Harts Farm Way, Havant

Stage 1 Road Safety Audit

Drawing No. 205465/PD03-Rev G – Proposed footway and Toucan Crossing

Appendix C

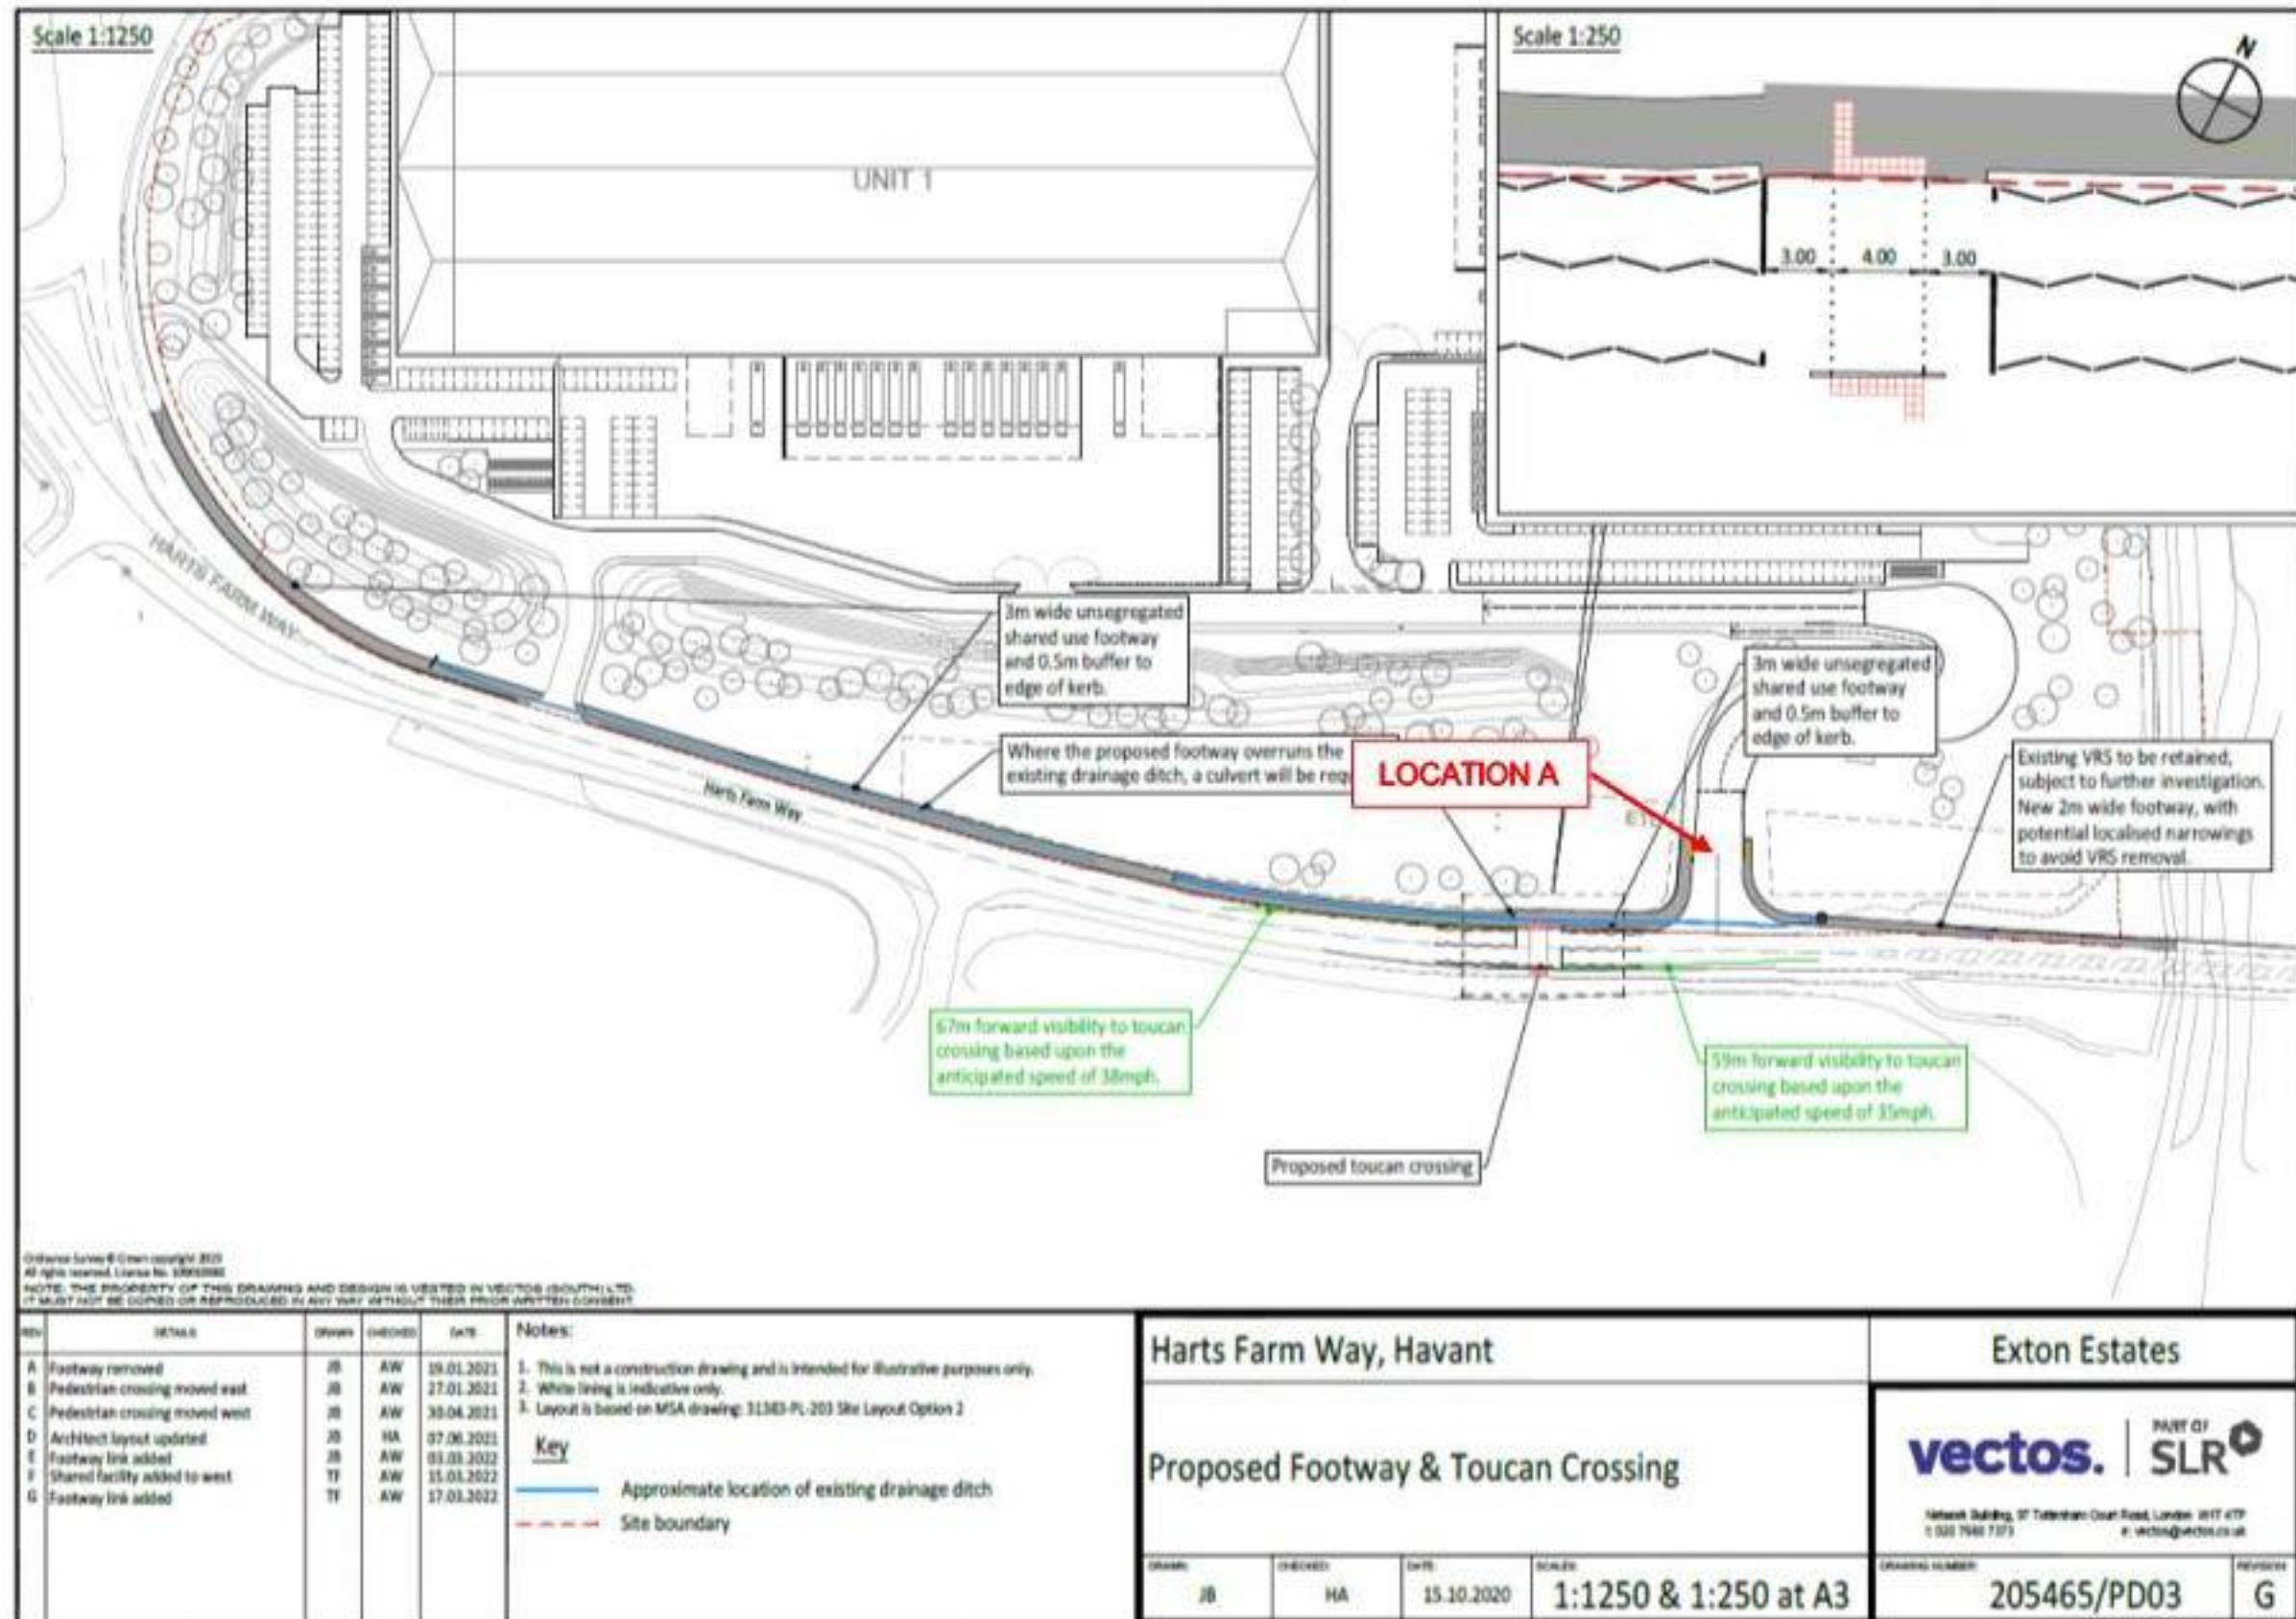
3.1 Problem.

Location A: Primary site access junction – proposed uncontrolled pedestrian crossing.

Summary: Location of the proposed uncontrolled crossing is away from the supposed pedestrians desire line which may lead to pedestrians crossing where it is unsafe at risk of trip type personal injuries or collisions between pedestrians and vehicles.

Designs drawings show an uncontrolled pedestrian crossing at the primary site access junction to the north of Harts Farm Way. This proposed uncontrolled crossing is located some distance into the site access minor arm and as such may be away from the pedestrian desire line. This arrangement may in turn lead to pedestrians crossing where it is not safe to do so potentially leading to trip type personal injuries or collisions between pedestrians and vehicular traffic.

3.2 Problem.

Location A: Primary site access junction – proposed uncontrolled pedestrian crossing.

Summary: No hazard warning tactile paving to indicate the end / start of the shared use cycleway may lead to confusion between NMU's and cause collisions between cyclists and pedestrians.

Designs drawings show a shared use cycleway to the west of the access junction. This shared use route terminates at the site access. Design drawings do not show the required hazard warning tactile paving to indicate the start / end of the shared use route. This arrangement may lead to confusion regarding the designation of the shared use / footway provision and may cause collisions between cyclists and pedestrians.

It is recommended that the uncontrolled crossing be relocated closer to Harts Farm Way where it may be more appropriate in terms of pedestrian desire lines.

It is recommended that the appropriate hazard warning tactile paving is installed on the western side of the site access junction to notify NMU's of the start / end of the shared use facility.
